SERVICE BULLETIN

APPLICABILITY: 2015-2017MY Legacy and Outback

NUMBER: 12-218-17

SUBJECT: Additional TIPS for Front Door Wind Rushing Sound Repair

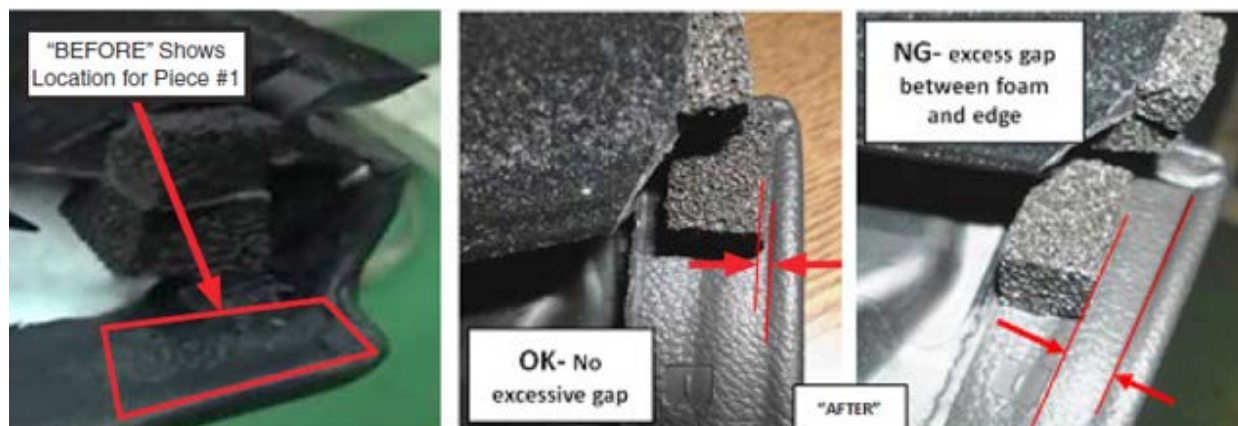
After road testing, confirming the condition and with the window all the way down (open), closely inspect the top rear corner of the door trim panel for any gap between the outer sash and door trim panel as shown below.

If the gapping condition (“NG”) shown in Figure 2 above is confirmed, **CAREFULLY** remove the affected door panel following the procedure outlined in the applicable Service Manual. Remove any residual EPT foam and / or adhesive with mild solvent on a clean shop cloth. Install a new EPT foam piece as described below.

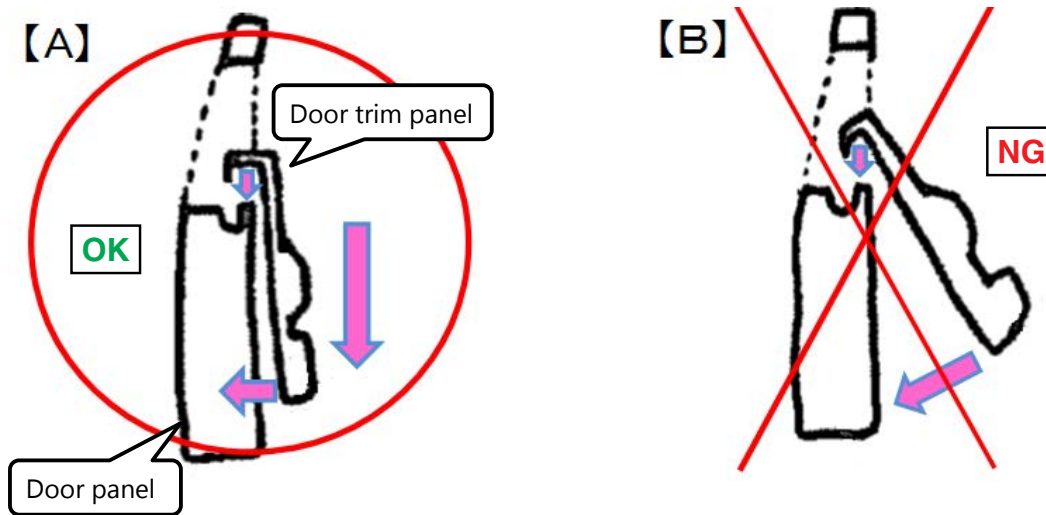
- **EPT Foam Piece #1** is applied to top **REAR** inside corner of the door trim panel where the trim material wraps around the back edge as shown in the “Before” and both the proper and improper installation “After” photos below. The NG photo shows an excessive gap between the foam and edge of the trim panel.

VERY IMPORTANT: When reinstalling the door trim panel, it must be **parallel** to the inner panel of the door frame as shown in illustration (A) below. This will keep the EPT foam from bunching up and causing a gap between the trim panel and sash to re-develop. **DO NOT** pull the bottom of the trim panel outward and “hook” the top onto the door frame like shown in illustration (B).
